ADDENDUM

Project Name:	Kosciuszko Middle School Toilet Room Upgrades	Addendum No:	One (1)
Project Number:	16-118	Issue Date:	April 29, 2016
Project Location:	Hamtramck, Michigan

To the Contract Documents for the requested Kosciuszko Middle School Toilet Room Upgrades

P101

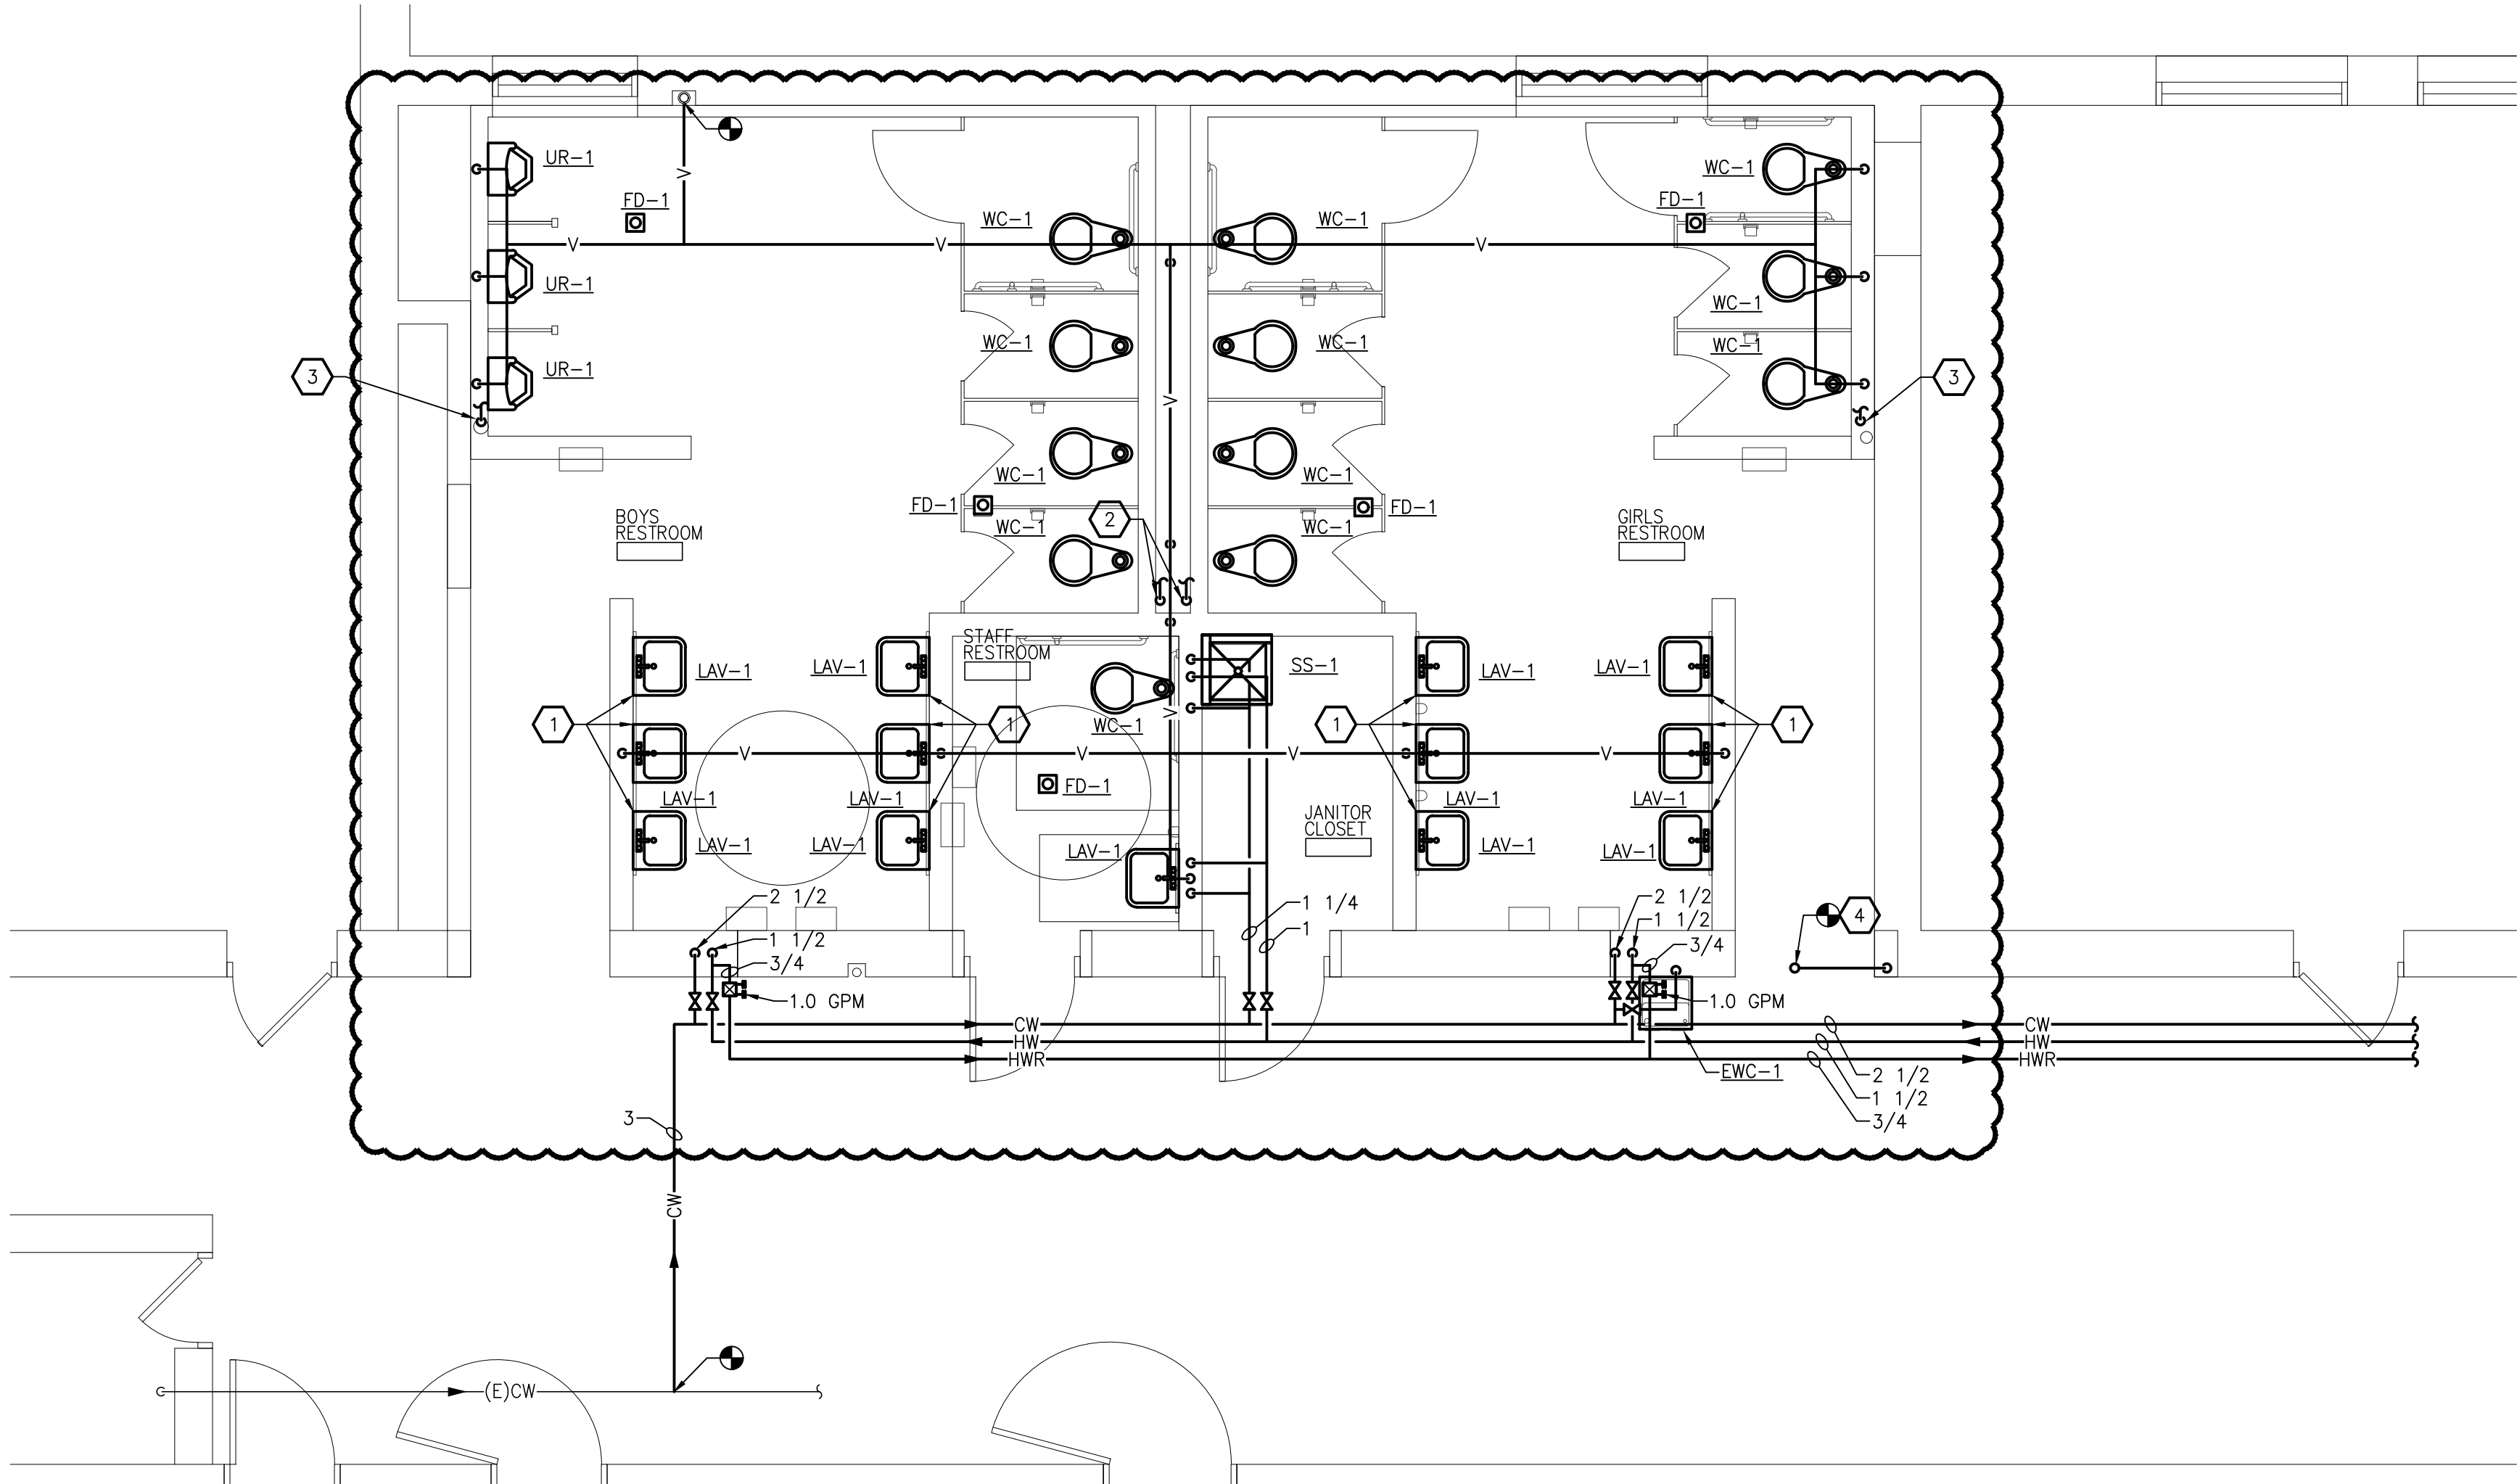
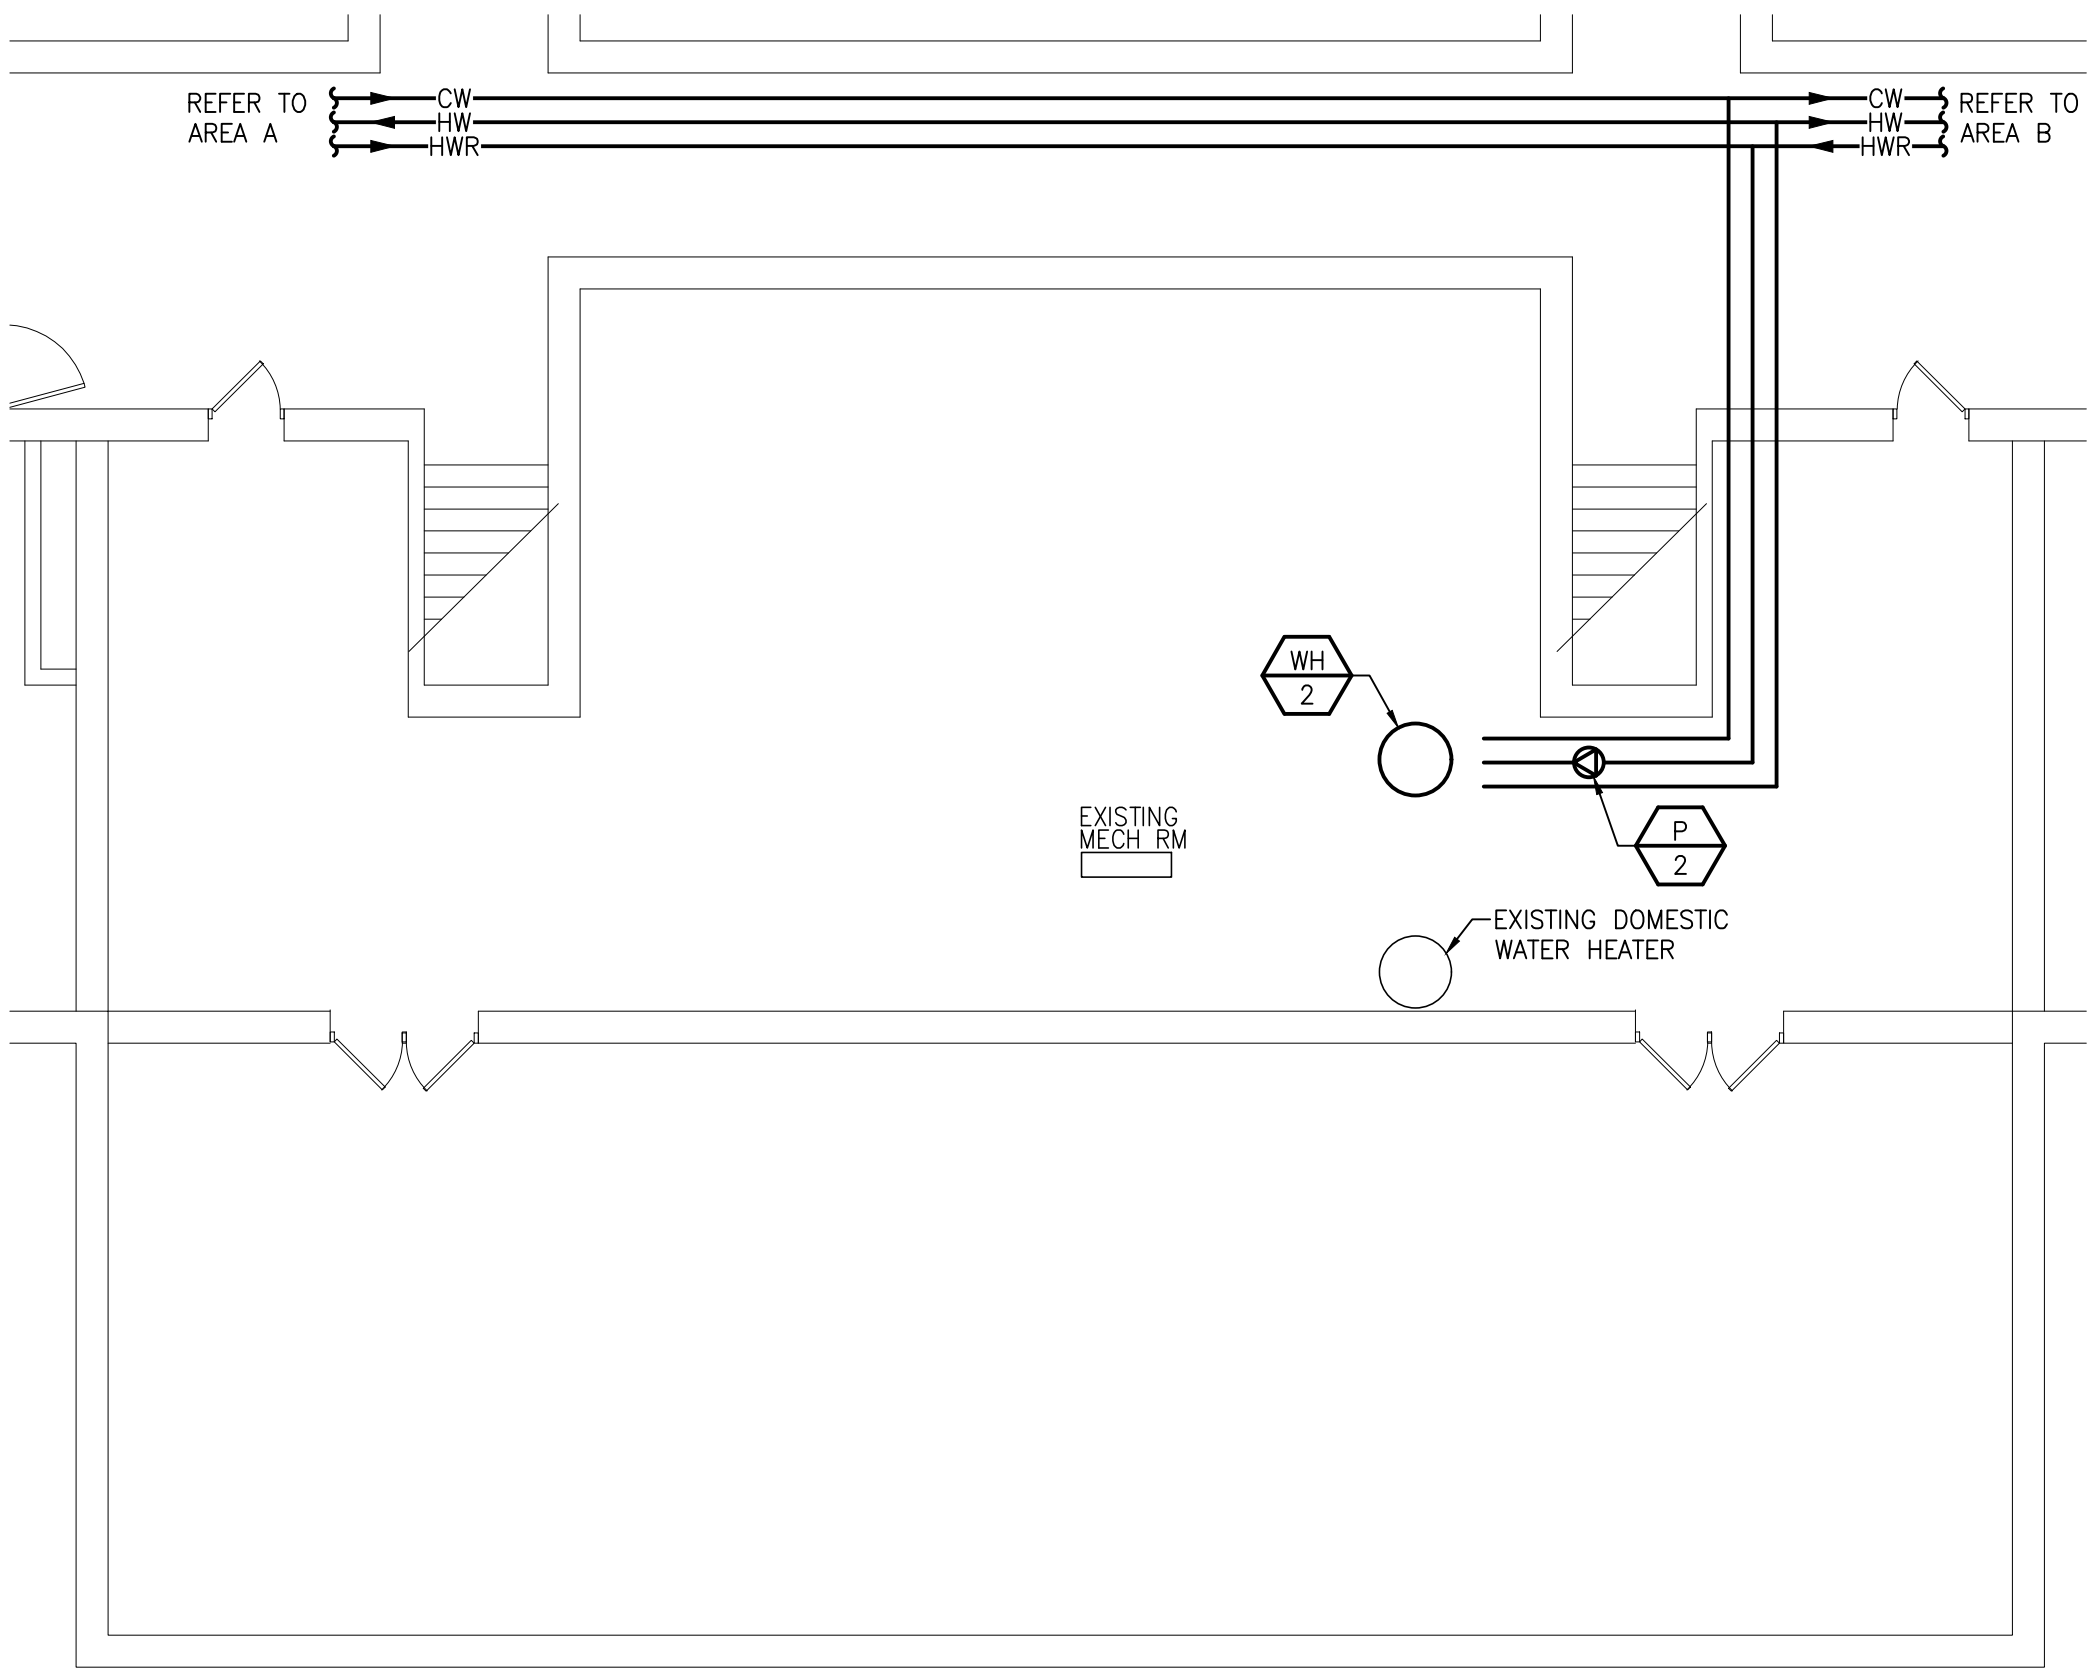
- Item M2 Drawing P-101 First Floor Plumbing Plan (revised and reissued this Addendum)
- A. Added electric water cooler (EWC-1) in Area A
 - B. Revised domestic hot and cold water piping serving the boys and girls restrooms in Areas A and B to route underground
